Norie's Bulletin of Corrections

No.2 from 1st April to 30th June 2025

The following new editions of charts have been published since Norie's Bulletin No.1 to 31st March 2024 was issued. These supersede previous editions for which corrections will no longer be available. New editions often contain extensive new hydrographic information or are new drawings.

Woodbridge Haven (Main chart & Plan G)

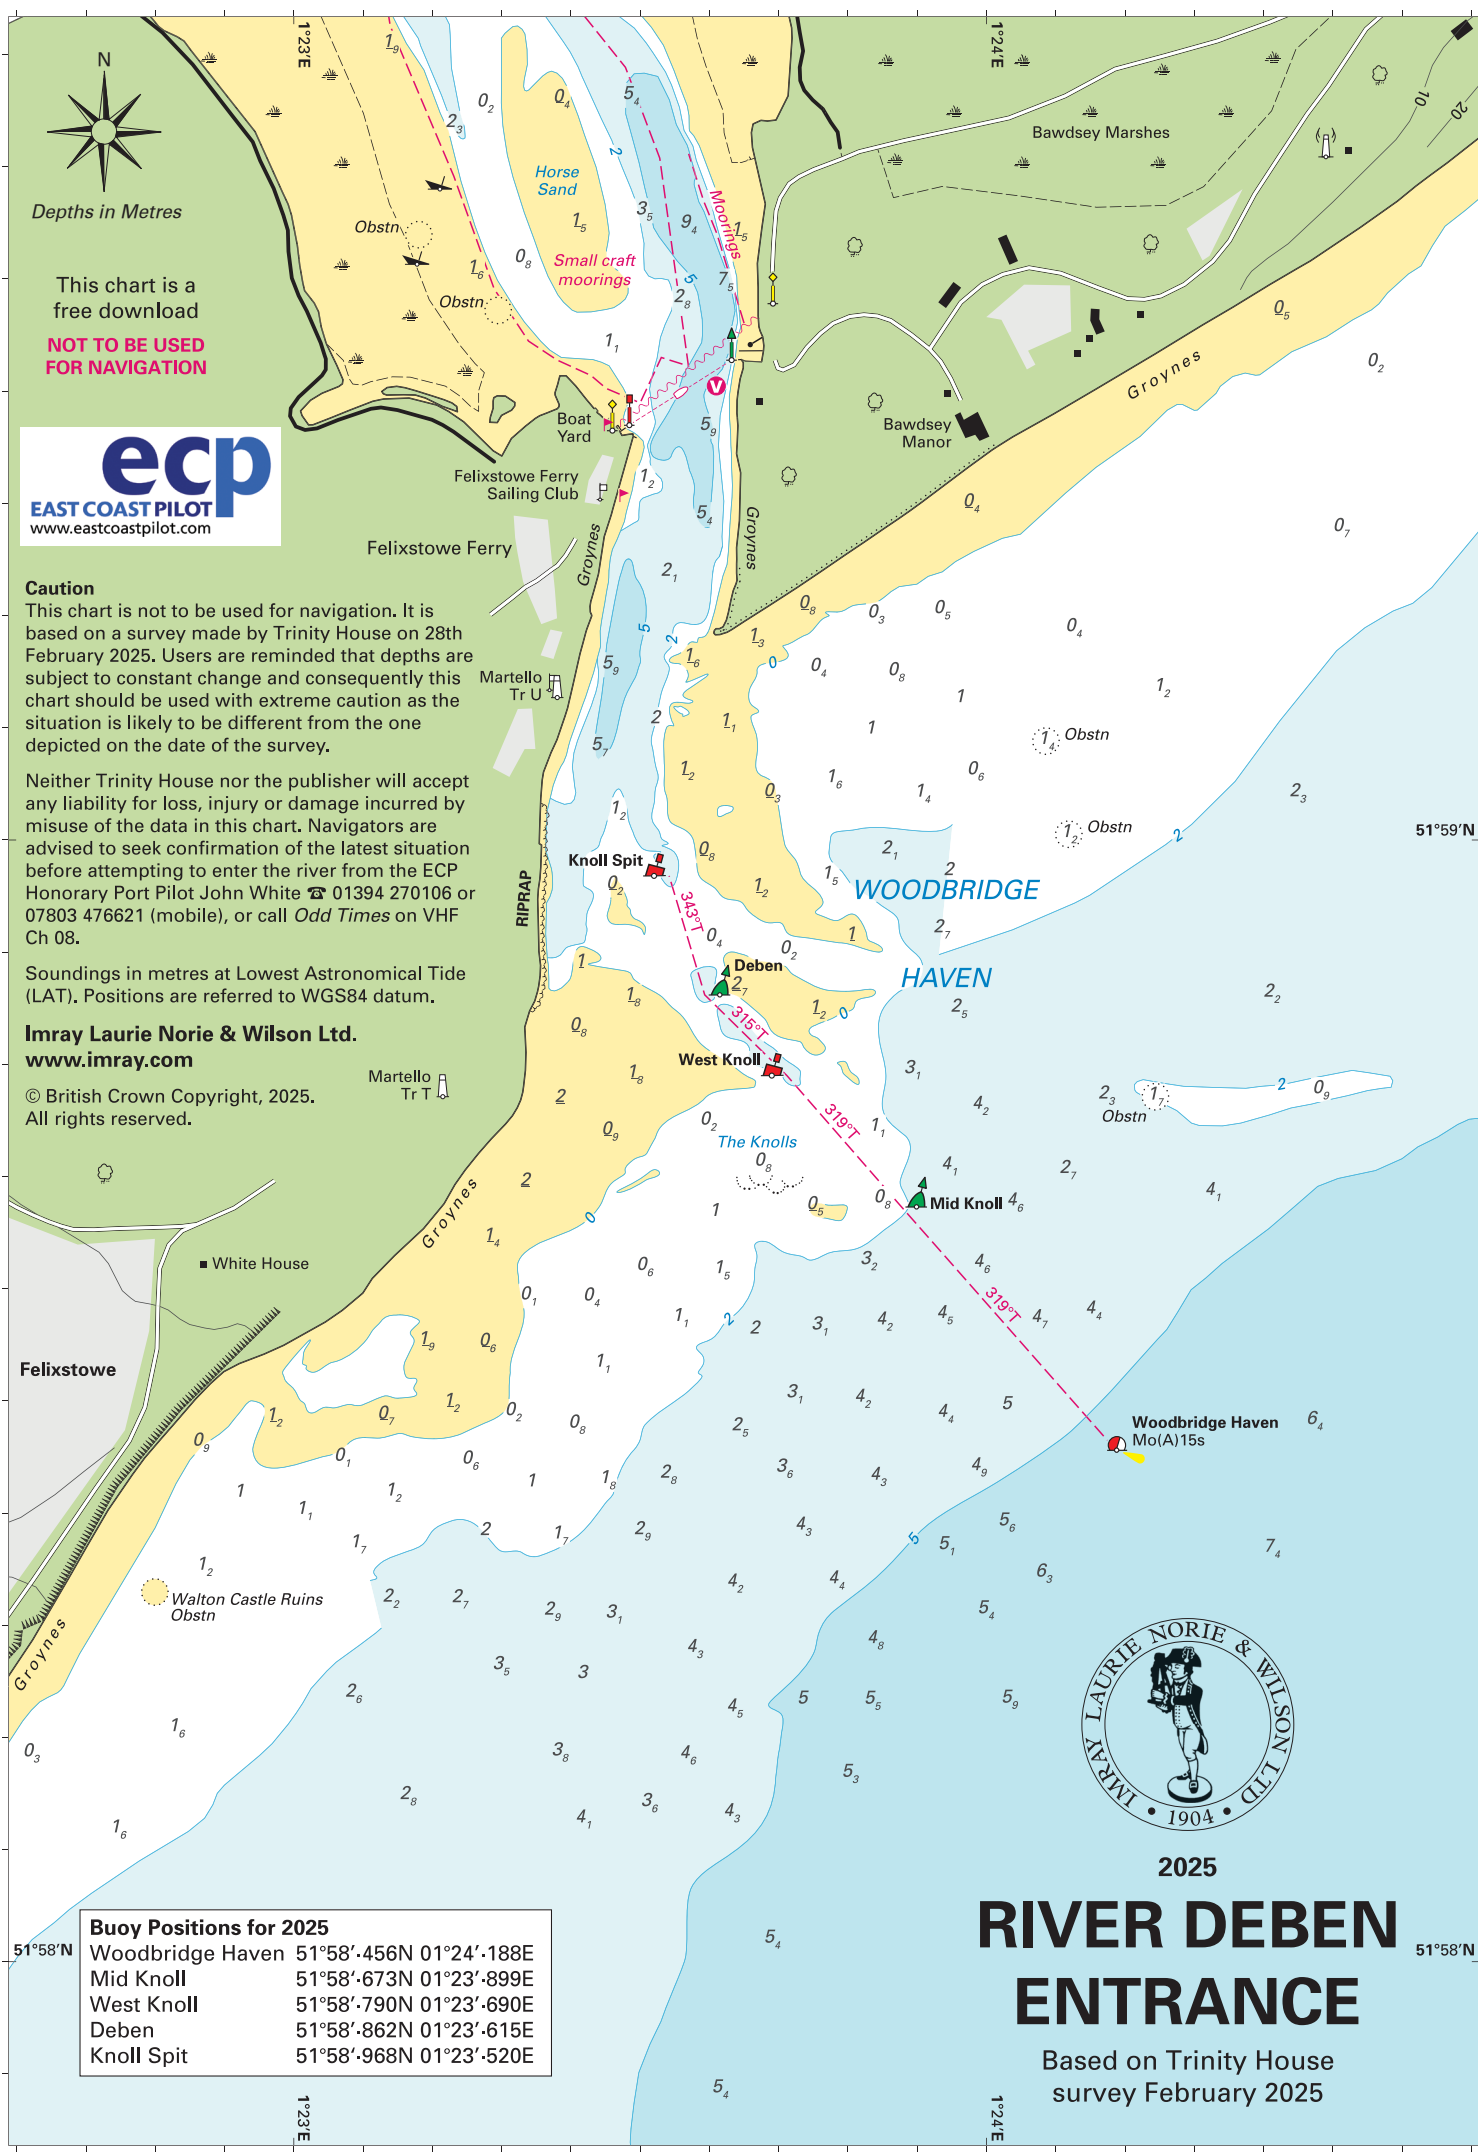
Move:

RW safe water buoy **Woodbridge Haven** Mo(A)15s to 51°58'·46N 1°24'·19E

G con buoy **Mid Knoll** to 51°58'·67N 1°23'·90E (Plan G)

G con buoy **Deben** to 51°58'·86N 1°23'·61E (Plan G)

R can buoy **Knoll Spit** to 51°58'·97N 1°23'·52E (Plan G)

R can buoy **West Knoll** remains in same position as last year.

For detailed information about the River Deben consult the accompanying chartlet (survey 02/25). For further details regarding the latest pilotage information and aerial photography of this area see www.eastcoastpilot.com (ILNW 48/25)

RIVER ORE ENTRANCE

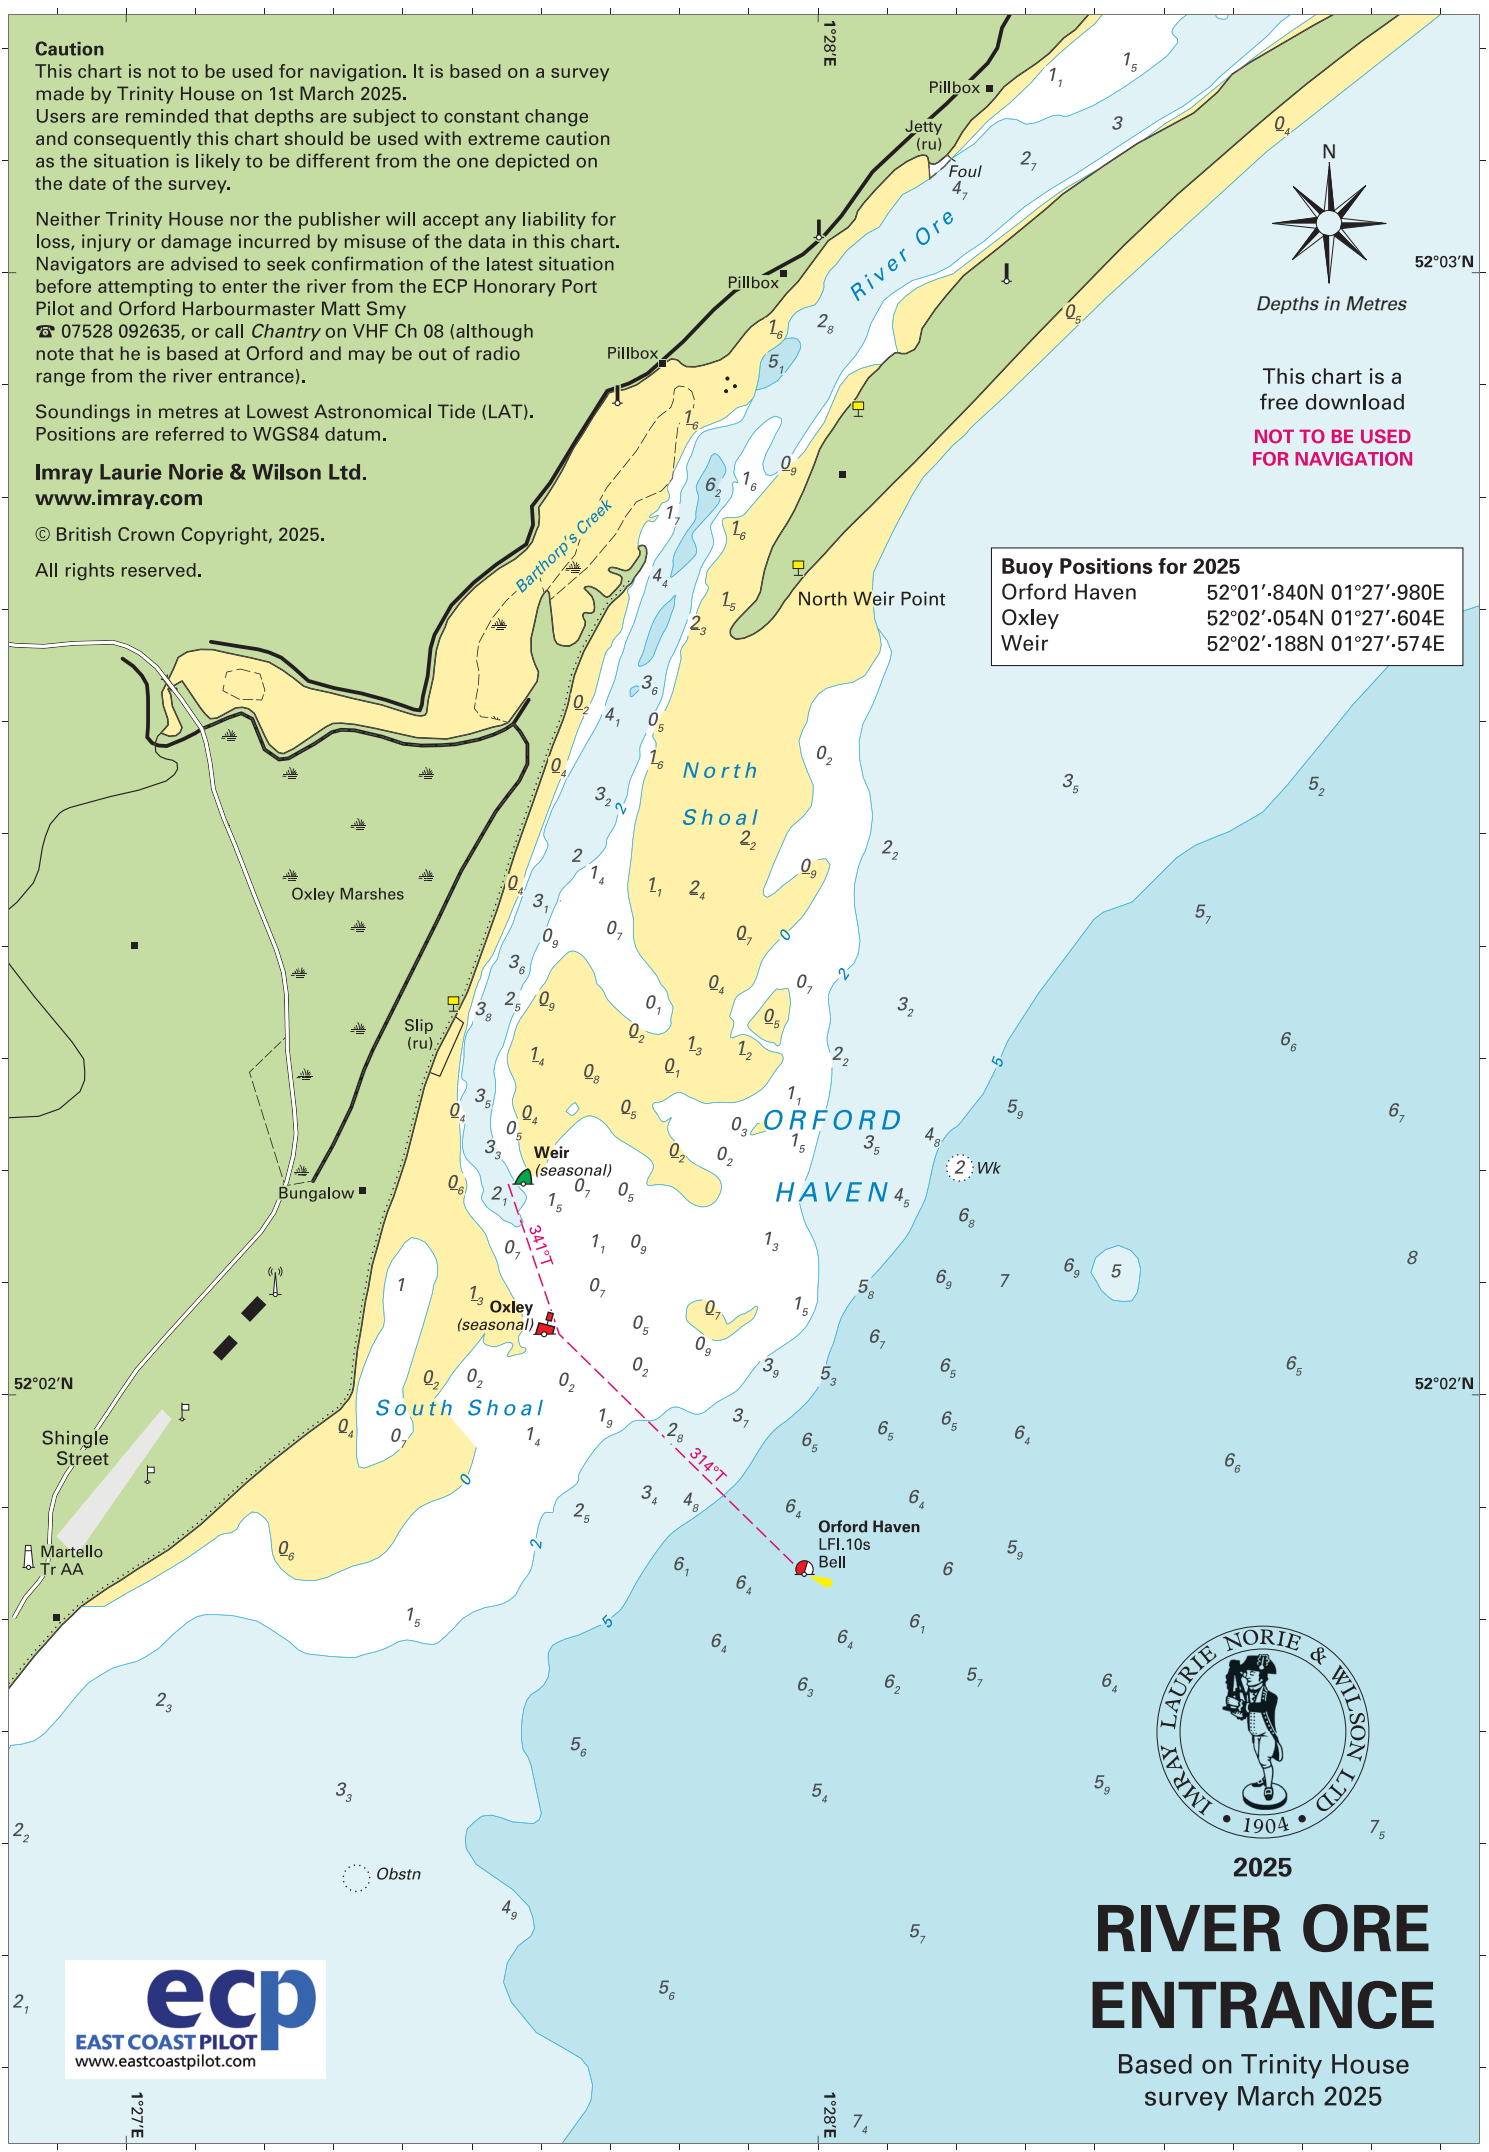
Orford Haven (Main chart & Plan F)

Move:

RW safe water buoy **Orford Haven** LFI.10s to 52°01'·84N 1°27'·98E

R can buoy **Oxley** to 52°02'·05N 1°27'·60E (Plan F)

G con buoy **Weir** to 52°02'·19N 1°27'·57E (Plan F)

Orford Haven	52°01'·840N 01°27'·980E
Oxley	52°02'·054N 01°27'·604E
Weir	52°02'·188N 01°27'·574E
